To: T10 Technical Committee  
From: Rob Elliott, HP (elliott@hp.com)  
Date: 23 June 2003  
Subject: 03-214r0 SES-2 Update to SAS Device Element Status descriptor

**Figure 1 — Filling in the Device Element Status descriptors**

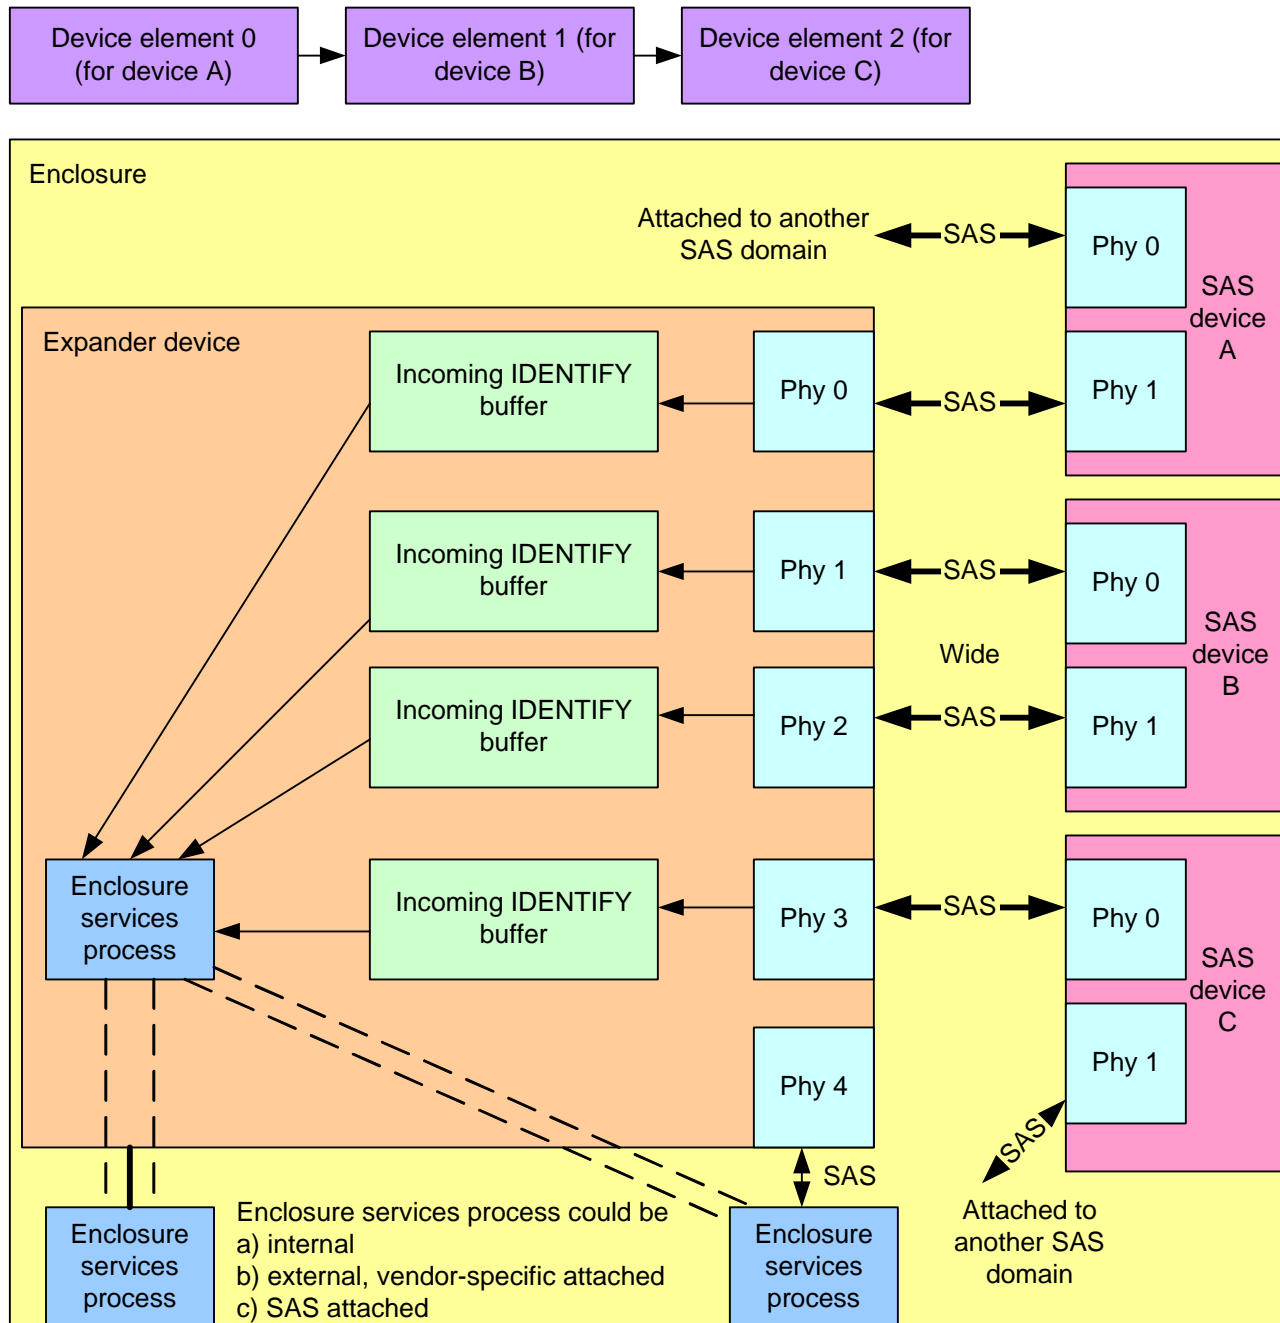
In this example, the enclosure services process knows there are 3 slots for SAS devices (based on the design of this enclosure), so it provides 3 Device elements (for A, B, and C). The slot for B uses a 2-wide physical link, showing that the element is for the device, not the port. The enclosure services process knows about phy 1 in SAS device A but not phy 0, since phy 0 is in another SAS domain, so the Device Element Status descriptor cannot include any details about phy 0. It knows about both phys in SAS device B, so can fill in information about them. It only knows about phy 0 in SAS device C.

If the enclosure service process has access to both domains (e.g. it is itself a dual-port SAS device attached to both expanders), it might know about phy 0 of device A and phy 1 of device C and be able to report more information.

The proposed descriptor allows the enclosure process to report any phys it knows about regardless of domain. The NUMBER OF PHYS field is replaced by NUMBER OFPHY DESCRIPTORS, and the phy identifier is included in the descriptor, so all phys need not be reported. The protocol bits are included to help figure out if it is a SCSI or ATA device; the attached SAS address is included to determine which domain each phy is in.
